SITE MONITORING REPORT SHEET

Site address: Fieldfare Avenue, Boorley Gardens, Hedge End
Developer: Halebourne Group Ltd.
Date of visit: 31/07/2026
Inspected by: Henry Pinn
ACD Project Ref: PRI24389

ACD Environmental Ltd. (ACD) conducted a site monitoring visit on 31/07/2026 for the development at Fieldfare Avenue, Boorley Gardens, Hedge End to address Condition 9 of the Planning Approval (ref: F/23/96629).

G14.1 – G14.3:

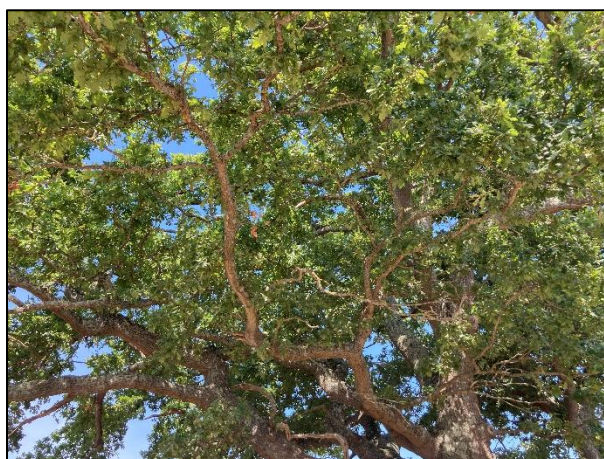
- Trees seen to be in good outward health with vigorous leaf flush and no indicators of stress of dieback.
- x1 large deadwood piece over 50mm^Ø visible from site office in mid-eastern crown aspect.

- Southern fencing is present and braced.
- Previous additional fencing to south has been removed for site logistics. Original braced fencing alignment remains.

- Eastern fencing is unbraced.
- Western fencing has been realigned 0.5m from Cellular Confinement Surfacing (CCS) surfacing within RPA in accordance with Tree Protection Plan. Fencing also partially covers area of future bin-store, but some soft ground exposed still. Re-aligned fencing has attached signage but currently un-braced. Fencing alignment showing signs of distortion as development traffic uses the area over CCS for material storage.

- Area of CCS surfacing previously installed has been covered with temporary sacrificial tarmac until installation of final wearing surface which has been confirmed will be of a porous design. Sacrificial tarmac to act as adequate ground protection.

- Development materials sited on sacrificial tarmac and within soft ground of RPA.
- Northern boundary treatment is in place and to act as suitable protective fencing alignment.

- **ACTION:**
 - Braced all tree protection fencing in correct position as shown on Tree Protection Plan.
 - Install adequate ground protection in areas as shown on Tree Protection Plan or fence area of soft ground within RPA off.

- Remove development material from soft ground within RPA.
